**27 Lot Development  
S.W. ¼ Sec. 28-47-1-W5M  
(north of Kerr Cape, Pigeon Lake)**

**Area Structure Plan**

**BY-LAW NO. 14-03**

**A BY-LAW OF LEDUC COUNTY, IN THE PROVINCE OF ALBERTA, TO AMEND THE SW 28-47-1-W5M AREA STRUCTURE PLAN ADOPTED BY BYLAW 26-02.**

GREGG PROPERTIES CO. LTD. - S.W. 1/4 SEC. 28-47-1-W5M  
AREA STRUCTURE PLAN  
BEACH ACCESS PLAN  
(FOR LOTS WITHIN APPROX. 400m OF THE LAKE)  
FIGURE 4.3 (as amended)

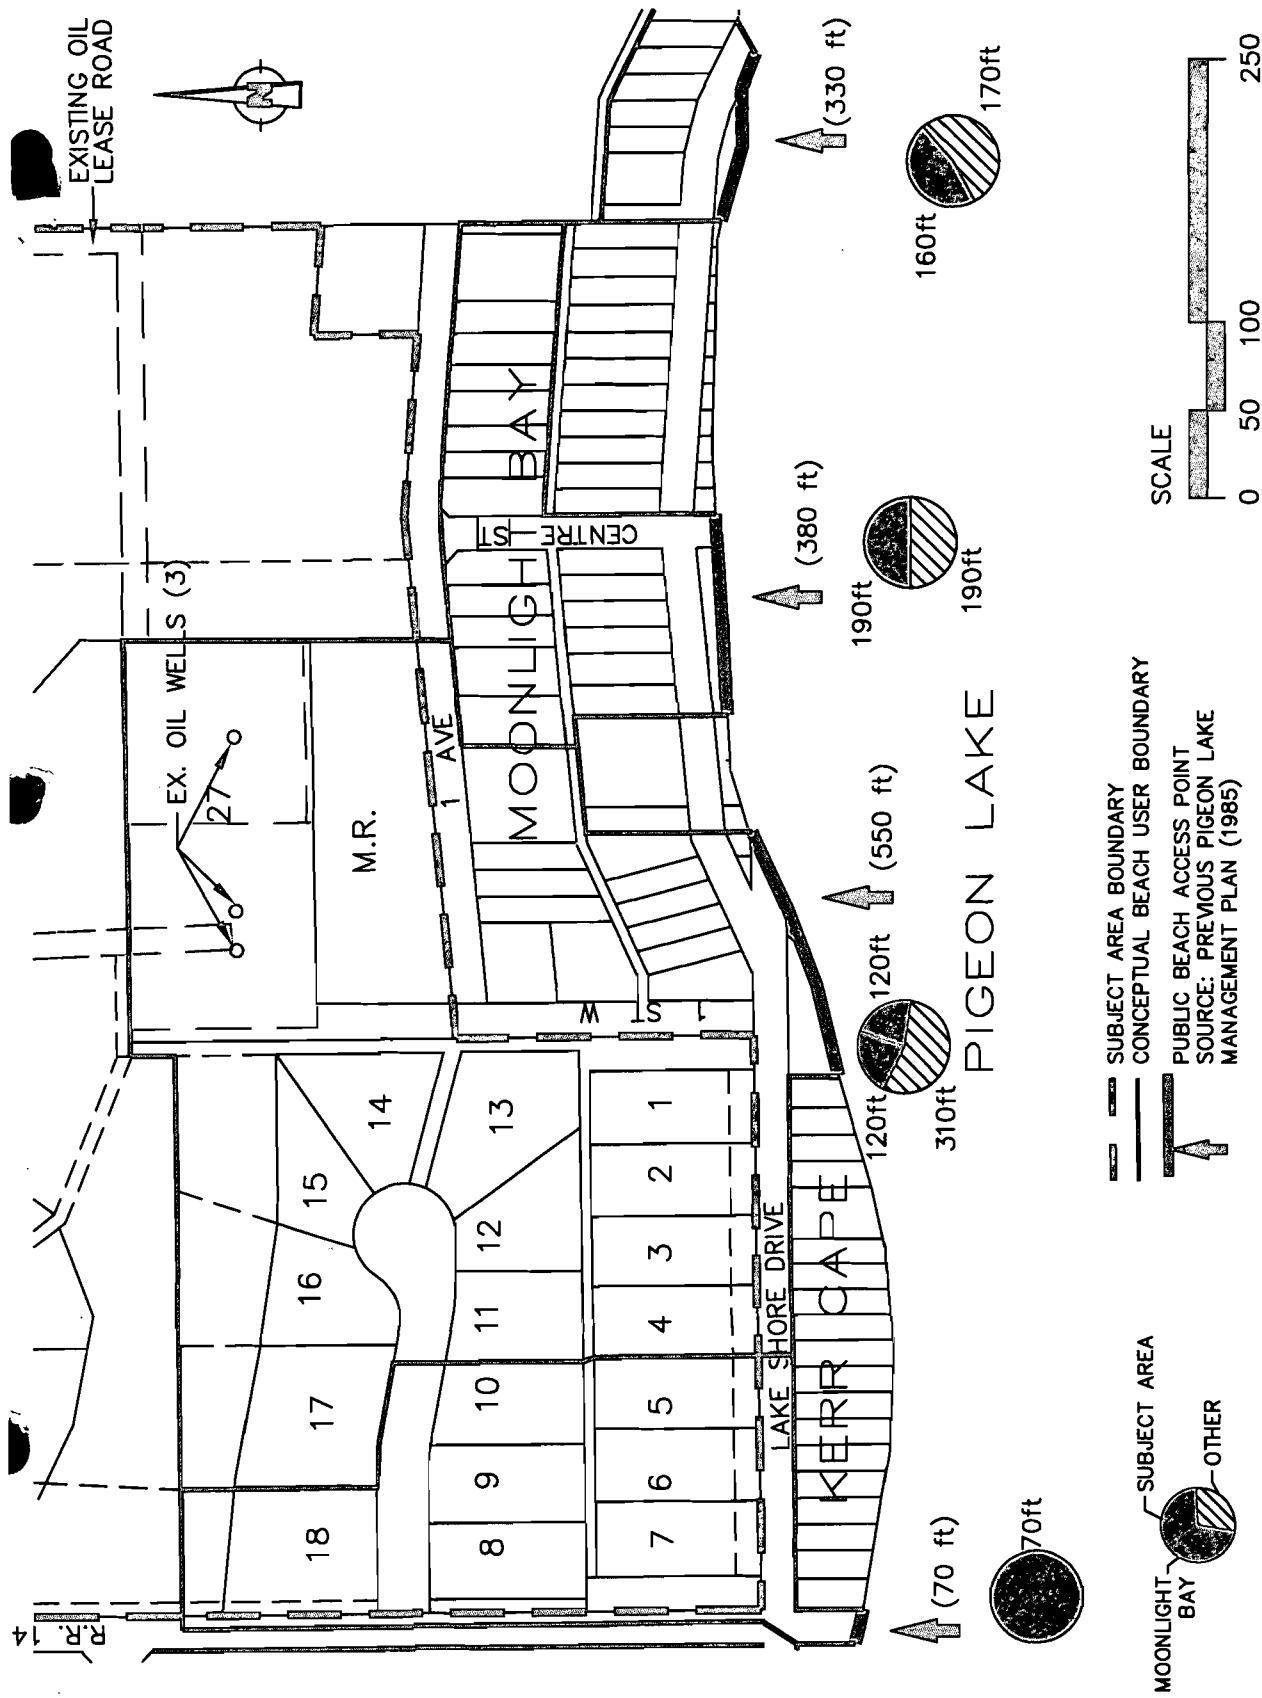
4. THAT the map that is attached to and forms part of this Bylaw be substituted for Figure 4.3 "Beach Access Plan";
5. THAT the words "Summer Village of Sundance Beach," be added after the words "the County," in paragraph 5 of Section 4.3, Lake Access.

- SUBJECT AREA
- SUBJECT AREA BOUNDARY
- CONCEPTUAL BEACH USER BOUNDARY
- ▲ PUBLIC BEACH ACCESS POINT
- SOURCE: PREVIOUS PIGEON LAKE MANAGEMENT PLAN (1985)
